SUBJECT: PLANS AND PROPOSAL ADDENDUMS
PROJECT: STP 2023 (675)MM CONTROL: 1433-02-044
COUNTY: COMAL
LETTING: 05/04/2023
REFERENCE NO: 0419

PROPOSAL ADDENDUMS

DESCRIPTION OF ABOVE CHANGES
(INCLUDING PLANS SHEET CHANGES)

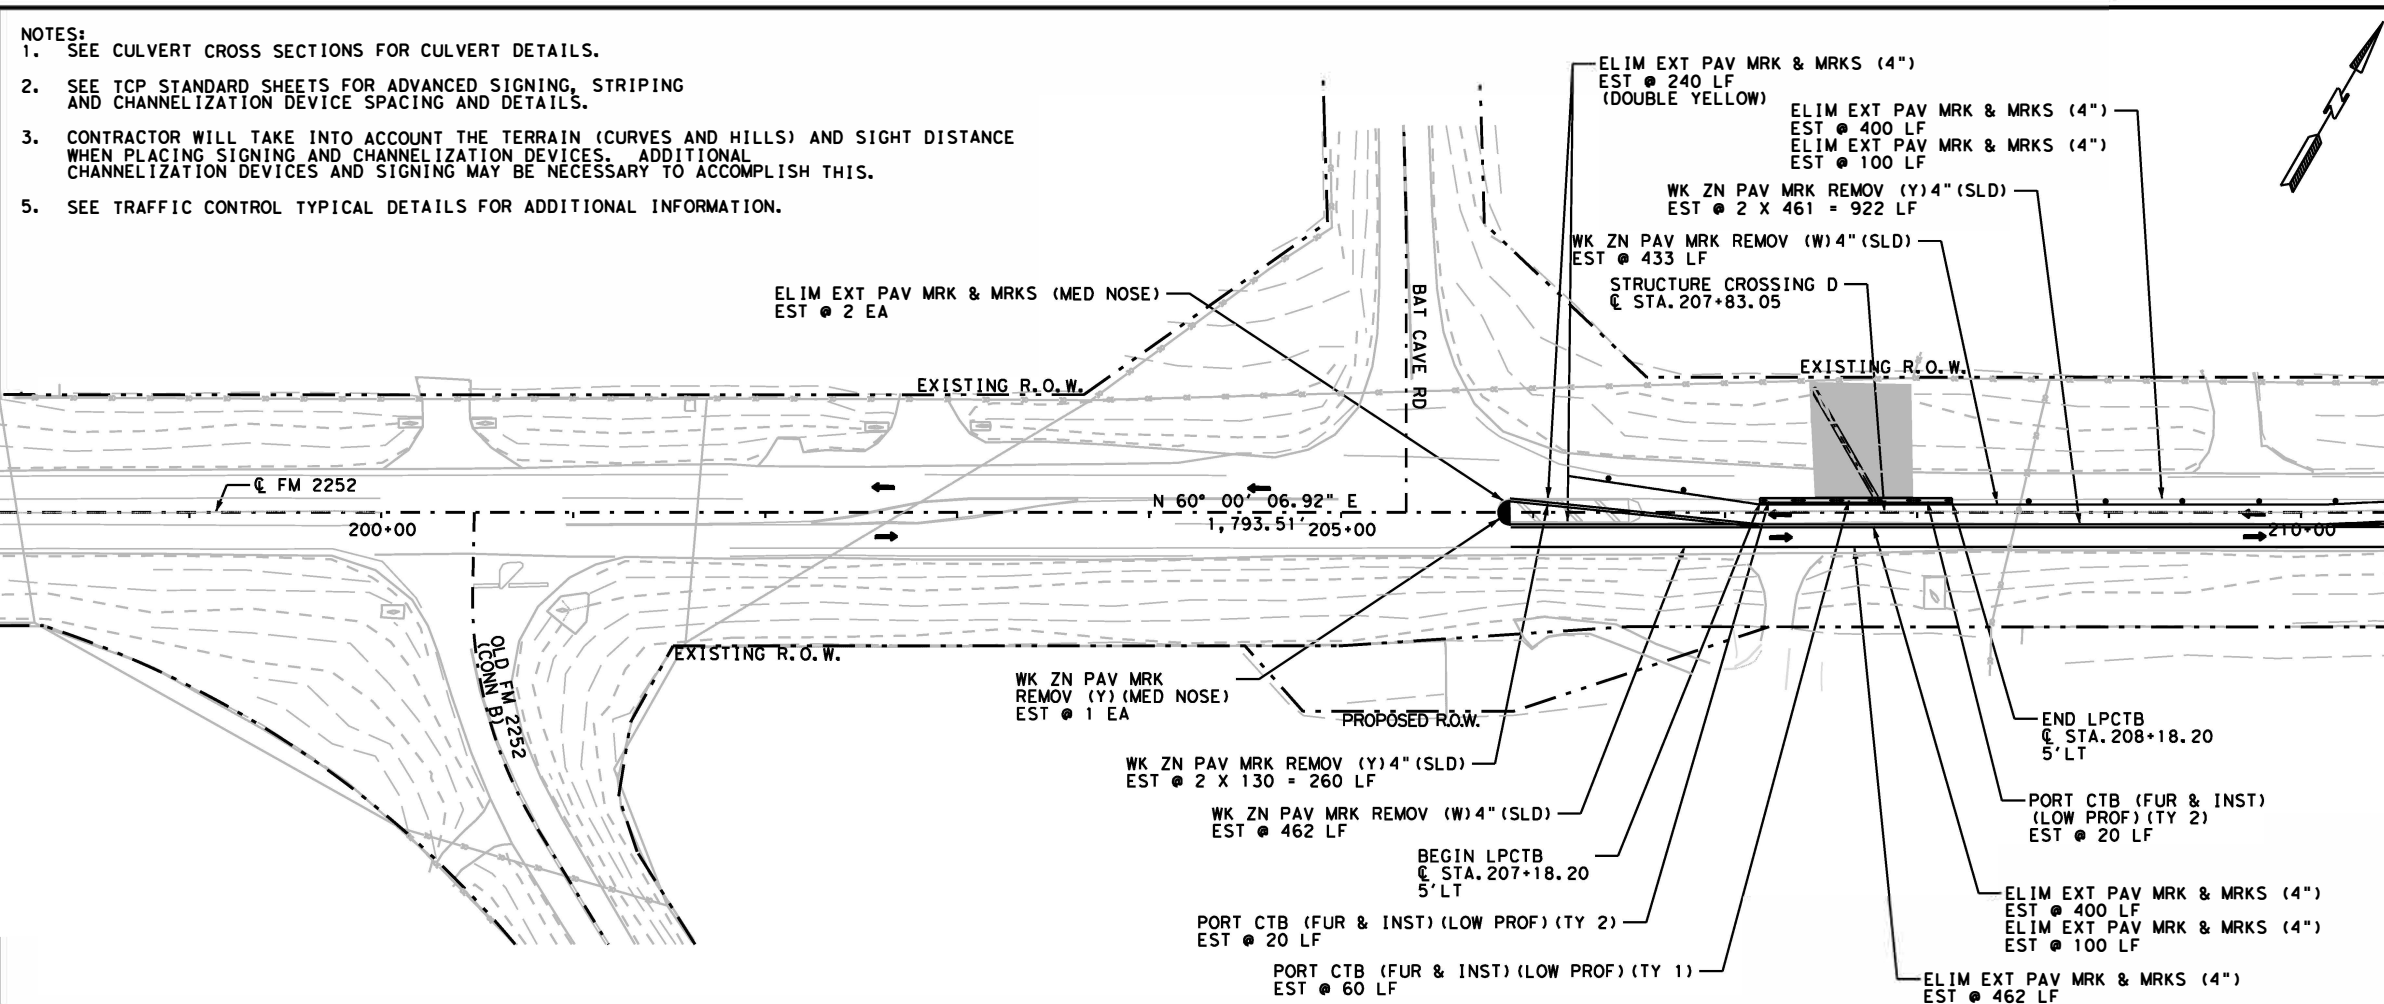
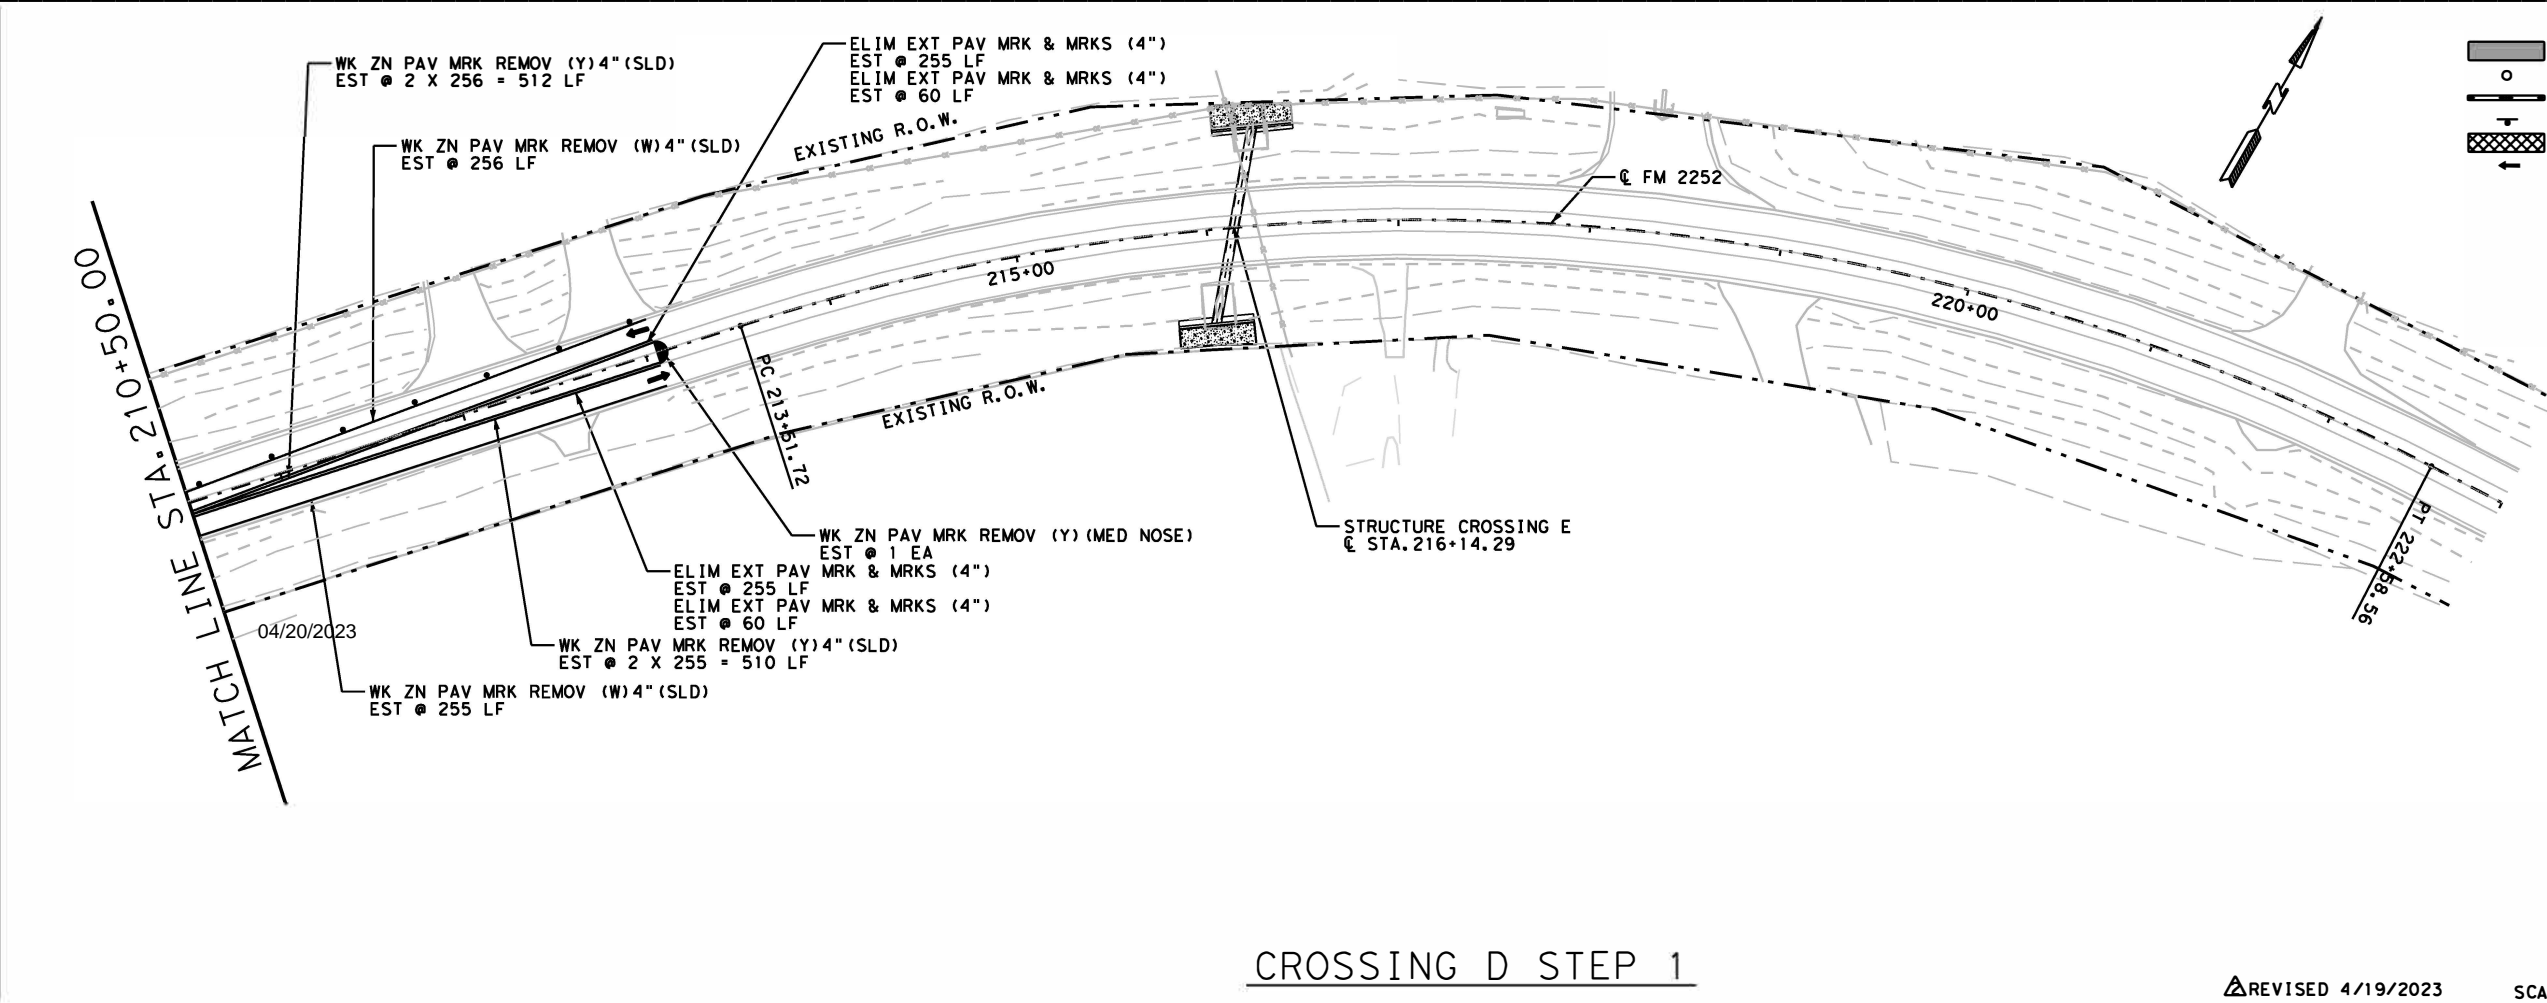
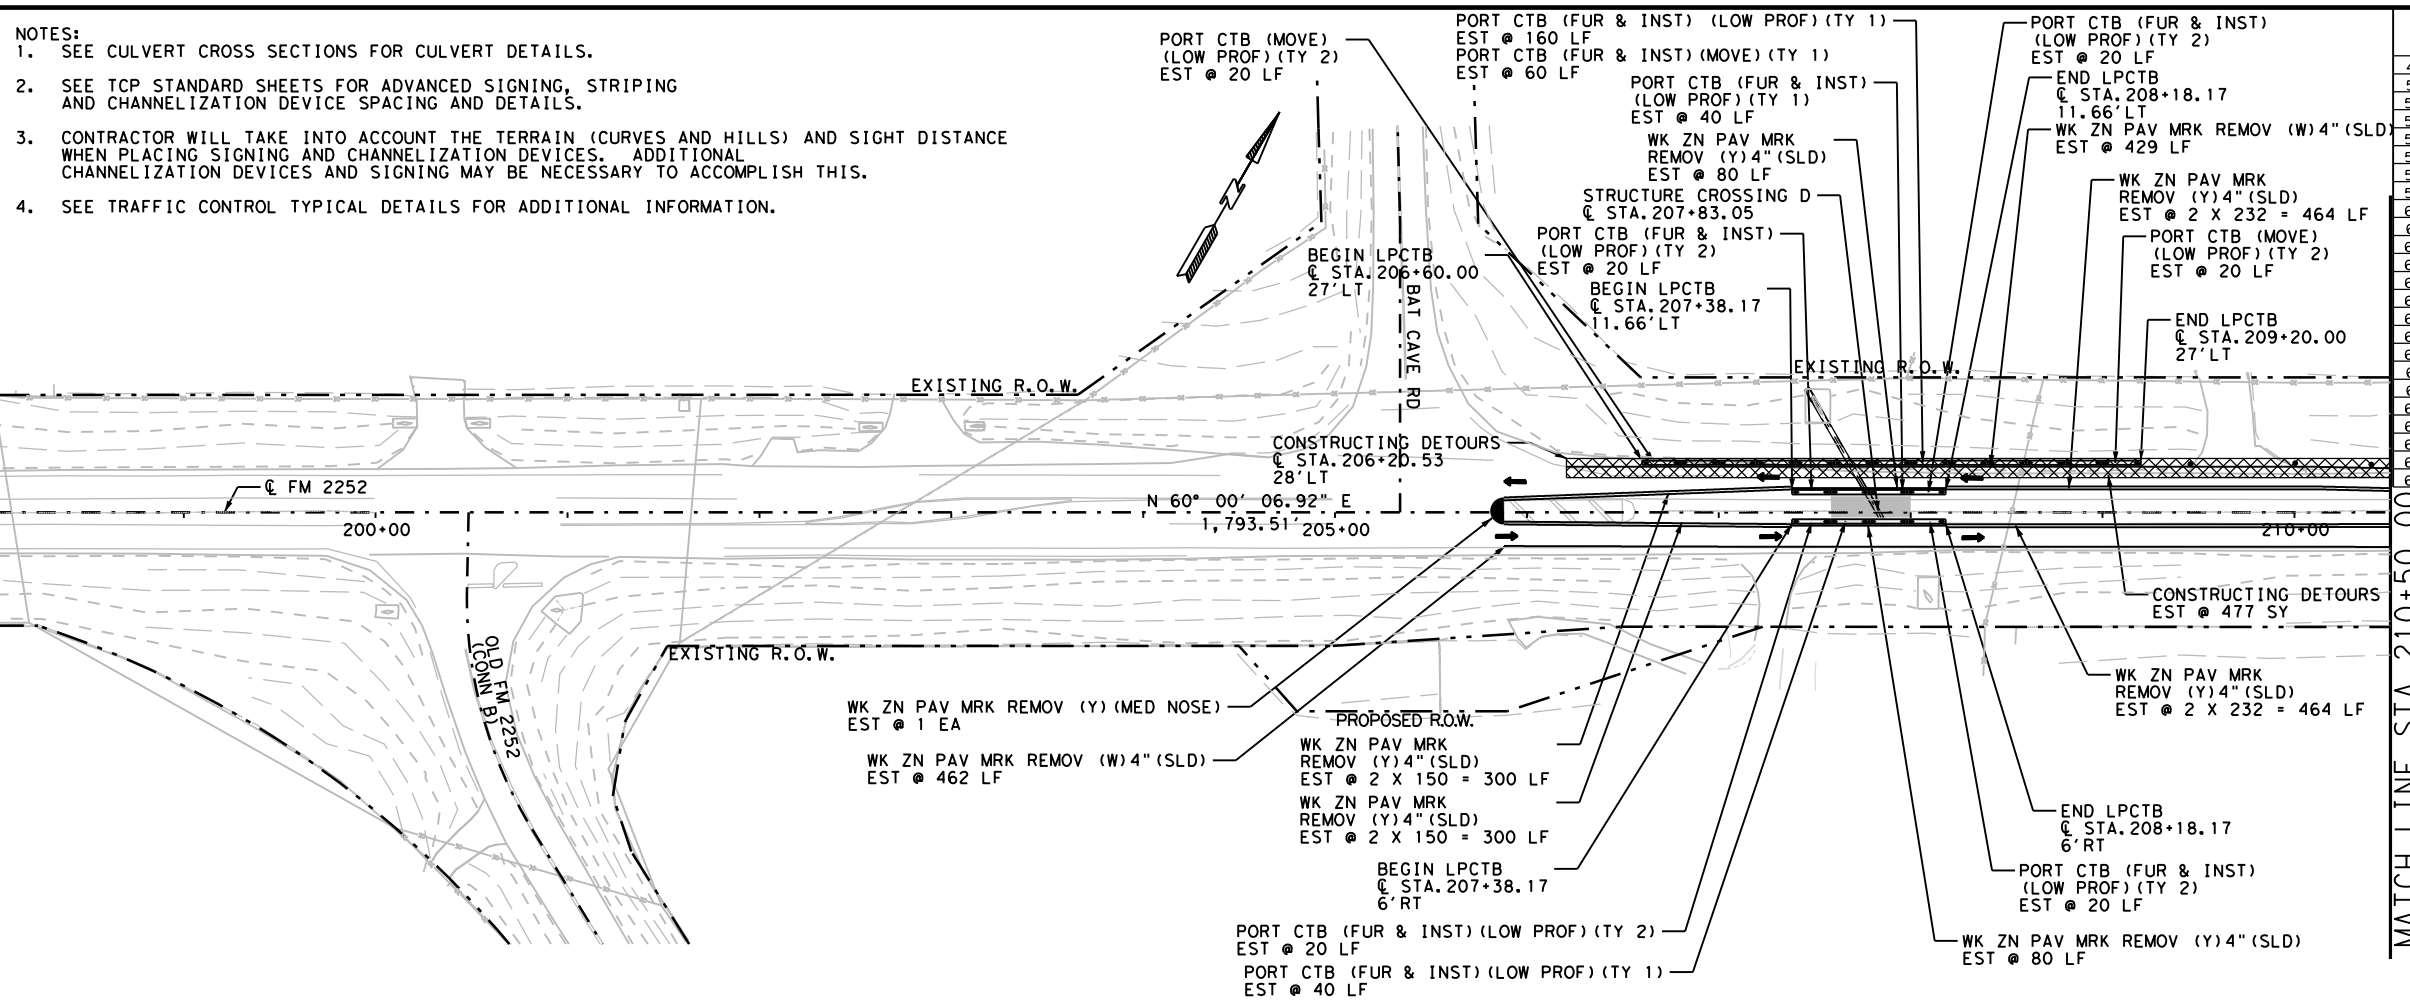
SHEETS 275-278, 280-283, 285-288 AND 290-293: ADDED ITEM NO. 403-6001
